1445 NEW YORK AVENUE NW

PROPOSED RENOVATIONS

COMMISSION OF FINE ARTS

CONCEPT REVIEW SUBMISSION

PUNCHED BRICK | TO 04

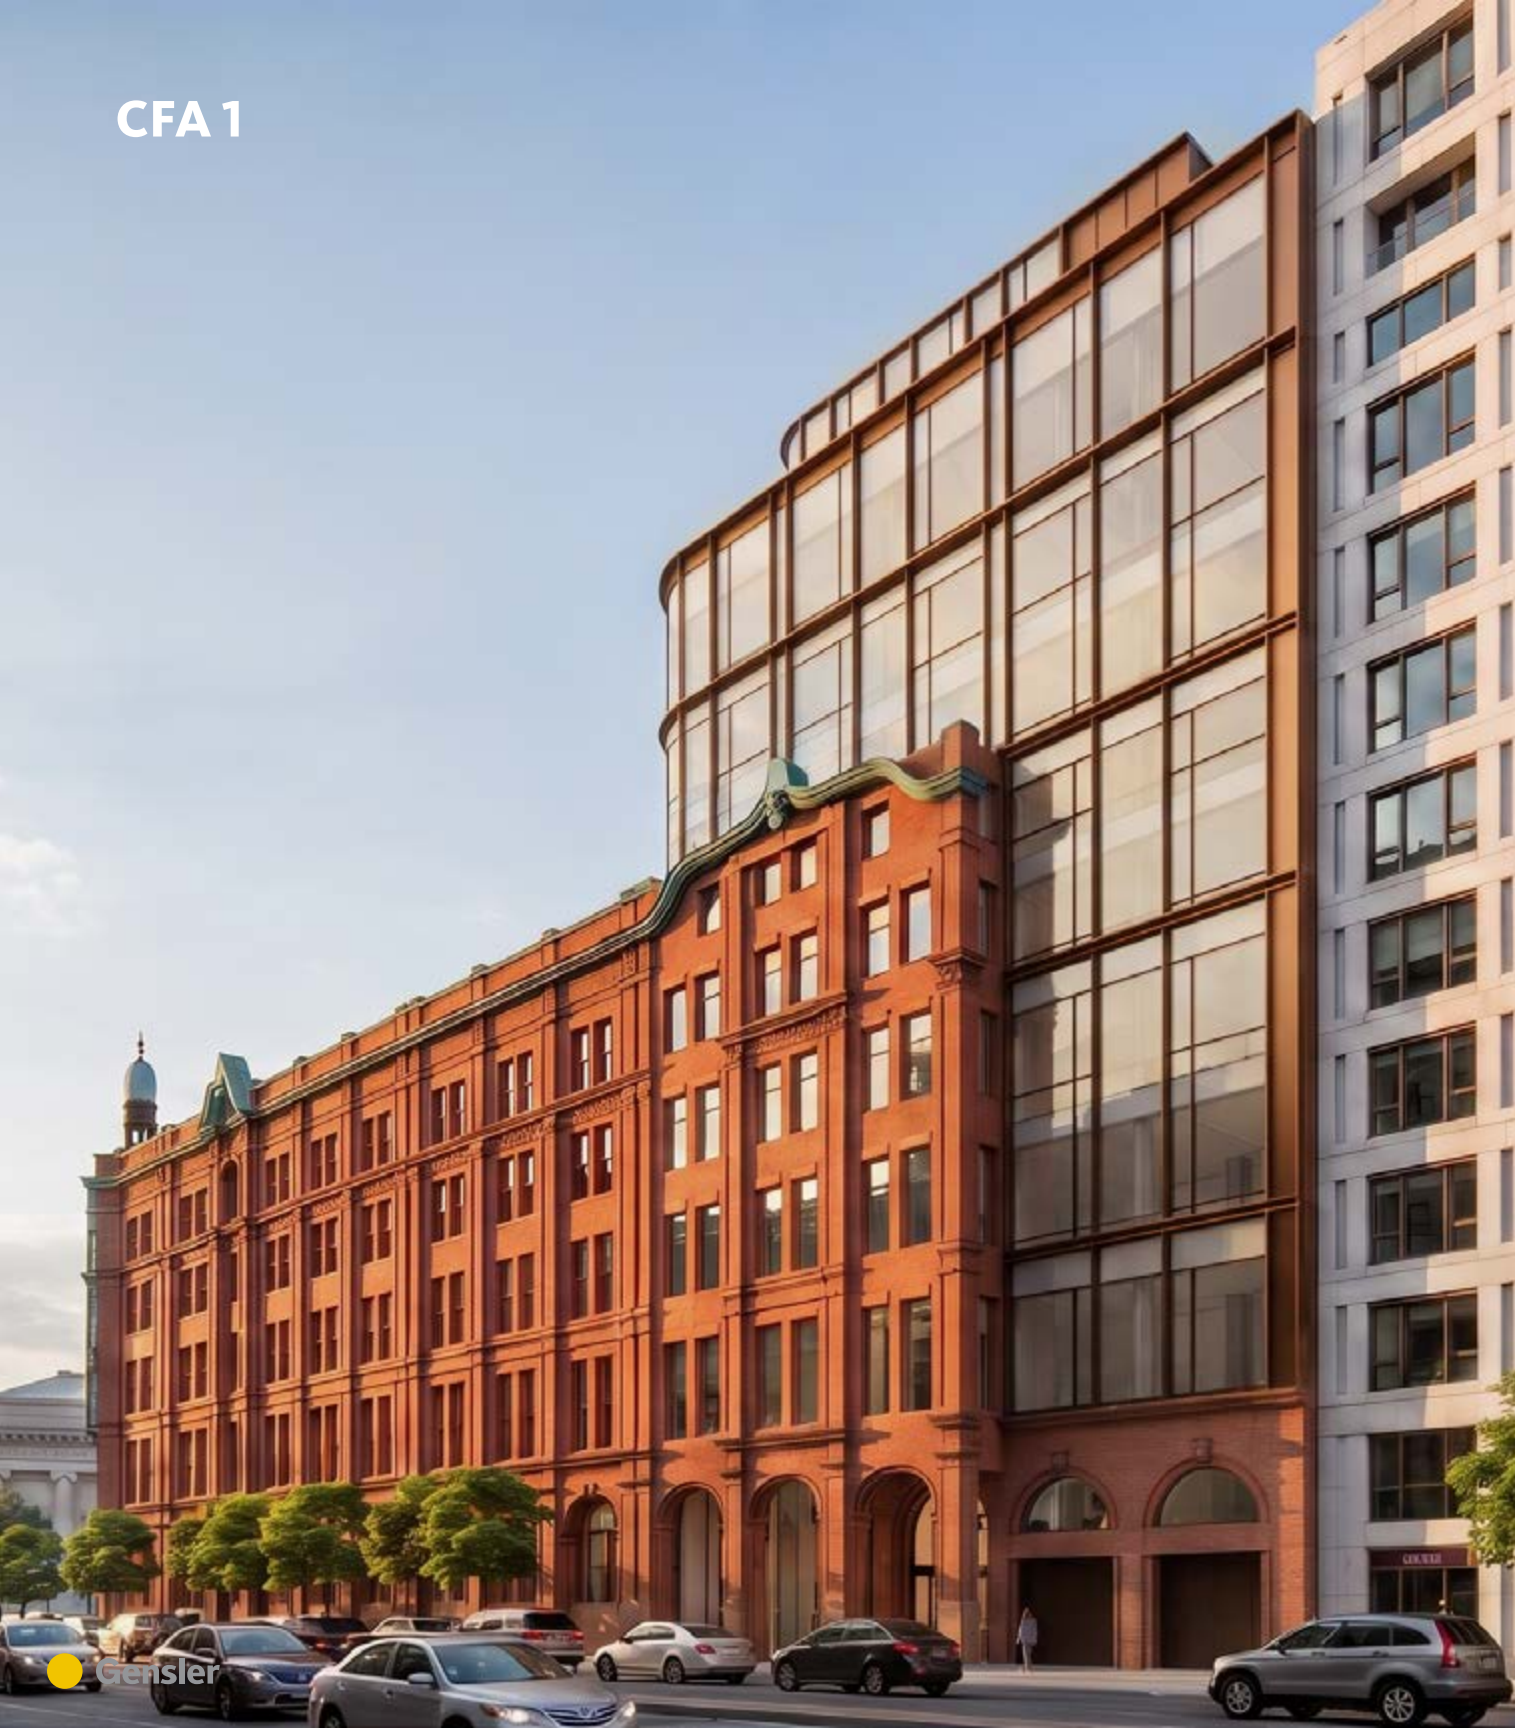
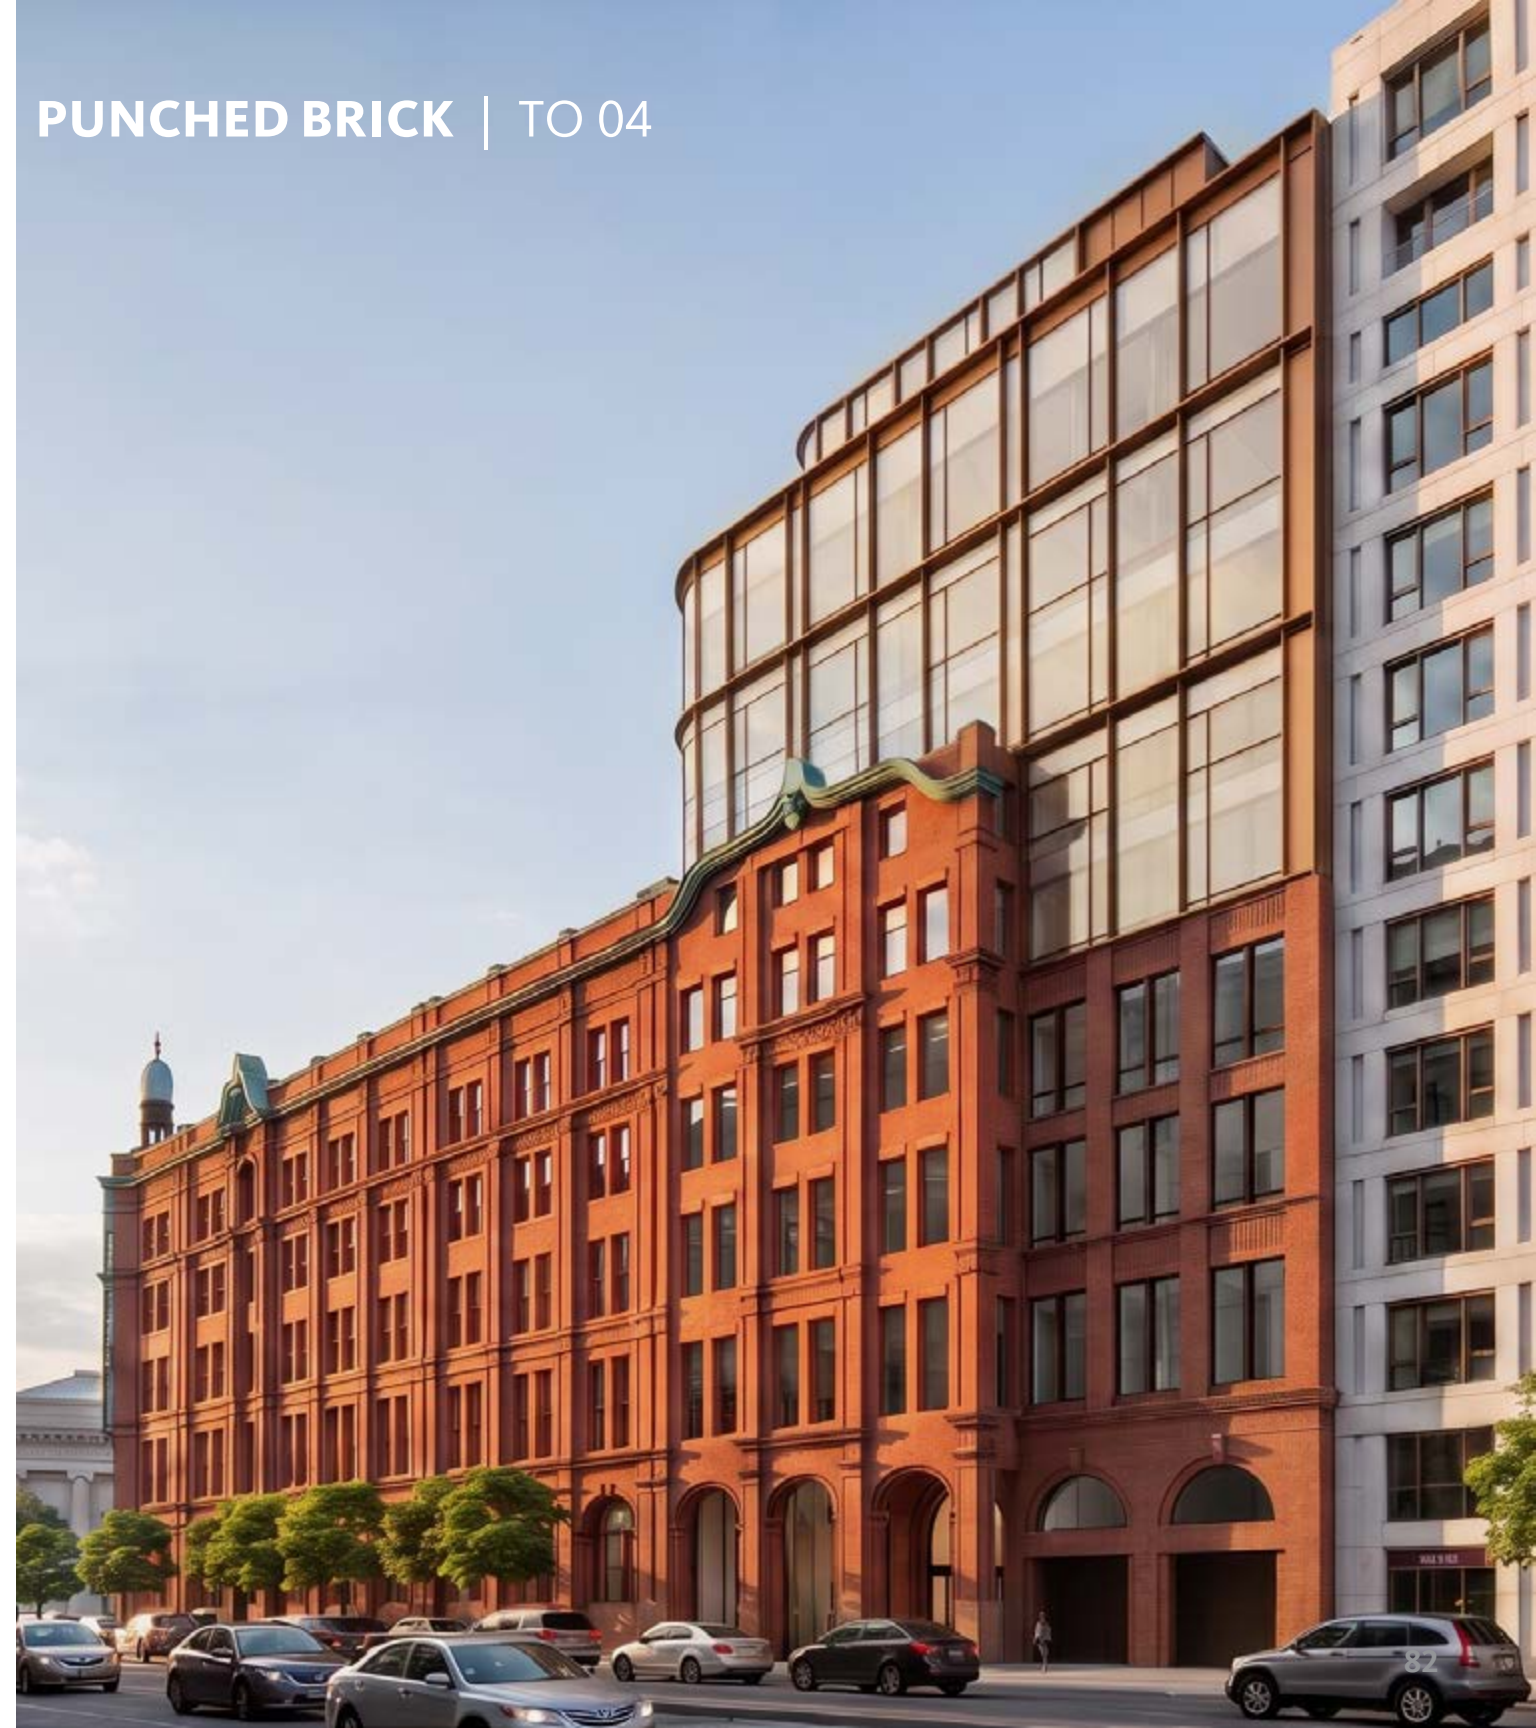
This area is recalling DC's unfortunate history with "façadomies." Study using brick up to the historic roofline and transitioning to glass above. Study extending new façade down to grade.

New brick with paired windows starting at 2nd floor. Advice from DC Historic Preservation was to not directly replicate 1984 transitional. Continuing the copper cornice would slice through 6th floor windows. Match 1984 brick with new or salvaged.

New brick terminates at historic 4th floor belt. This has the effect of highlighting the 'historic' volume and roofline (1984 transitional included).
